SUBJECT: EPA Comments on "Assessment of Dam Safety of Coal Combustion Surface Impoundments: GenOn New Castle Power Plant, West Pittsburg, PA"

DATE: **October 21, 2013**

From: [Frank, Stephen](#)
To: [Englander, Jana](#); [Hoffman, Stephen](#)
Subject: Comments Request on Coal Ash Site Assessment Round 12 Draft Report -New Castle Generating Station
Date: Friday, December 13, 2013 9:30:36 AM
Attachments: [Revised PRNT Figure 2 Page from New Castle - Draft Dam Safety Assessment Report 2012-11-30.pdf](#)
[New Castle Bottom Ash Pond Discharge Piping 2006.pdf](#)

FIGURE 2

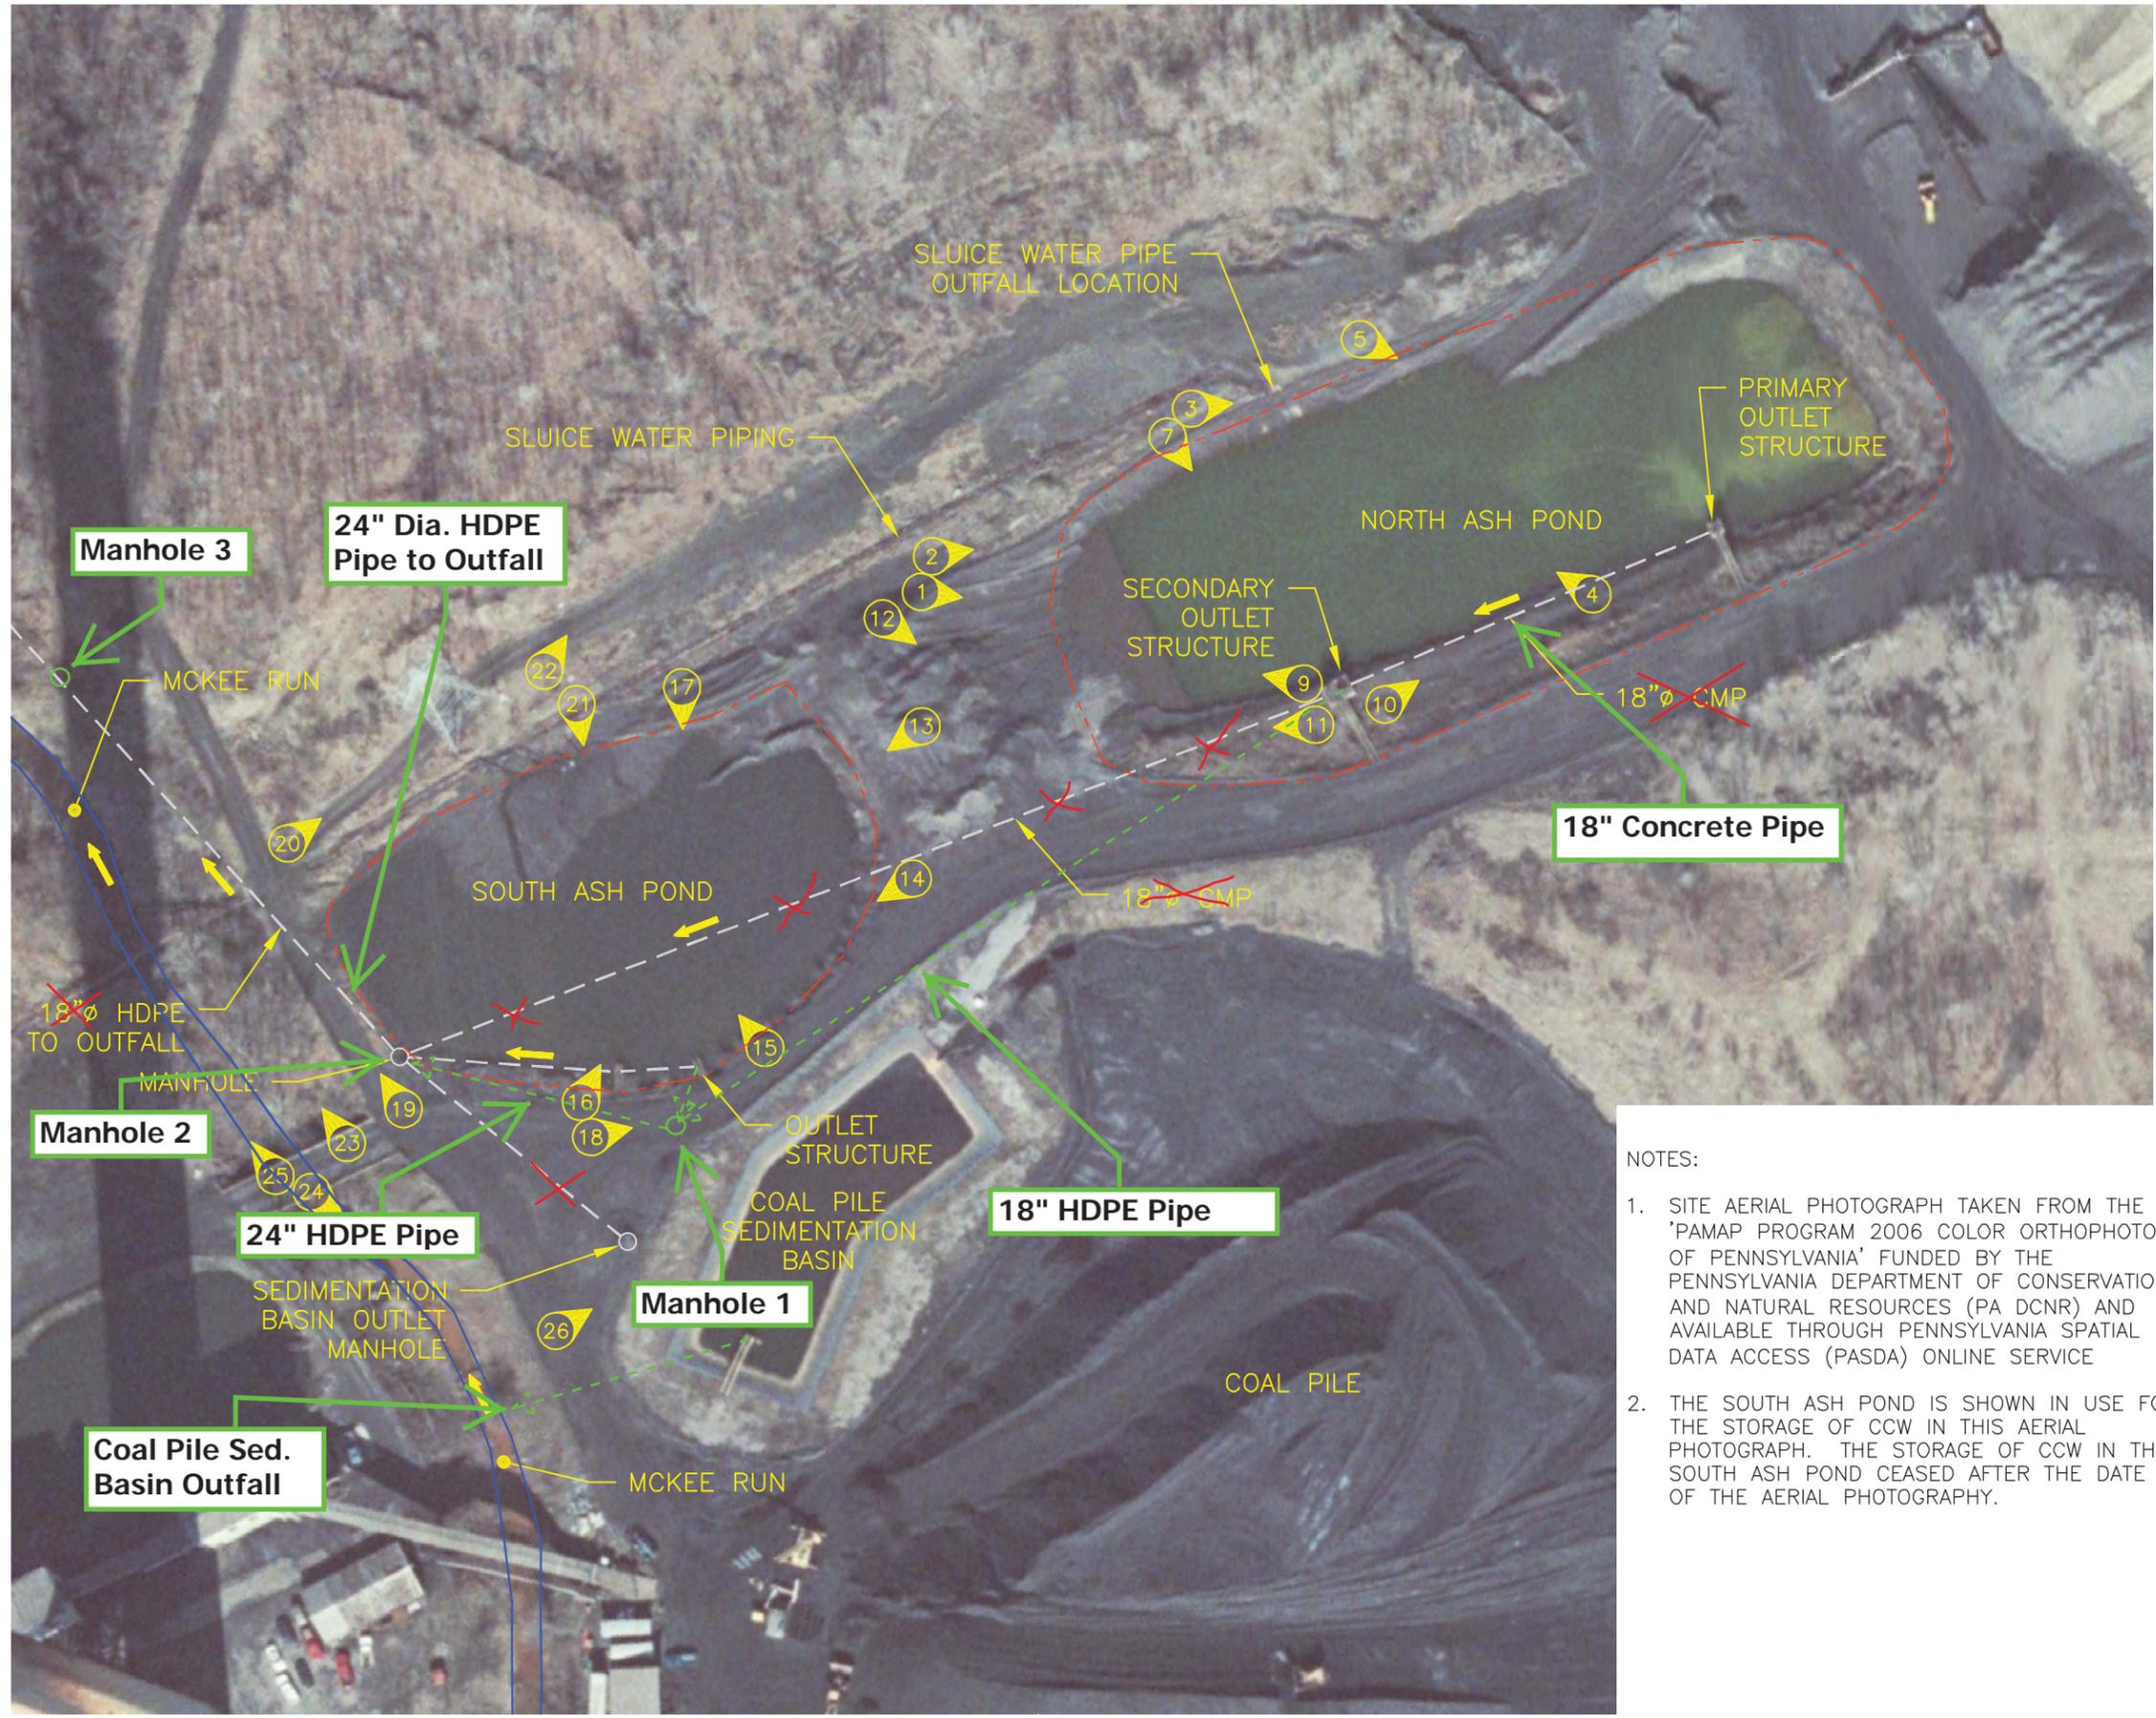
- The station owner and operator is NRG Power Midwest LP (NRG), a subsidiary of NRG Energy, Inc. and should replace "GenOn Energy" throughout the report.
- Page 2, note that while fly ash is dry handled, the ash is moistened to control dust prior to transport to the onsite landfill.
- Page 6, Section 2.3.3 Outlet Works. (See Revised Figure 2 and attached drawings)

The North Ash Pond has two outlet structures located along the eastern bank. The northern primary outlet structure consists of a concrete box with a rectangular weir equipped with stop logs to govern the water level in the pond. A steel slide gate serves as a baffle to exclude floating debris from the discharge. The top consists of an open steel grate. The effluent discharges into an 18" ~~corrugated metal pipe (CMP)~~ concrete pipe which extends below the bottom of the pond to the southern secondary outlet structure. ~~The concrete pipe was inspected in 2006 and found to be in good condition.~~ The secondary outlet structure consists of a concrete box with two separate rectangular weirs equipped with stop logs and slide gate baffles. The secondary outlet stop logs are set at a higher elevation than the primary outlet structure's stop logs and are used for overflow control. The effluent discharges into an 18" ~~CMP~~ HDPE pipe which extends ~~beneath the bottom of the Northern Ash Pond, through the embankment separating the North and South Ash Ponds, beneath the South Ash Pond along the access road~~ and discharges into ~~Manhole #1 a manhole~~ located ~~between the Coal Pile Sedimentation Basin and the South Ash Pond.~~ ~~on the southern crest of the South Ash Pond.~~ From ~~Manhole #1 this manhole~~ the effluent is conveyed by a 24" high-density polyethylene (HDPE) pipe, ~~transitioning to a 24" HDPE pipe for the last segment prior~~ to the outfall at the Beaver River. This outfall is permitted as Outfall 004 under NPDES Permit #PA0005061.
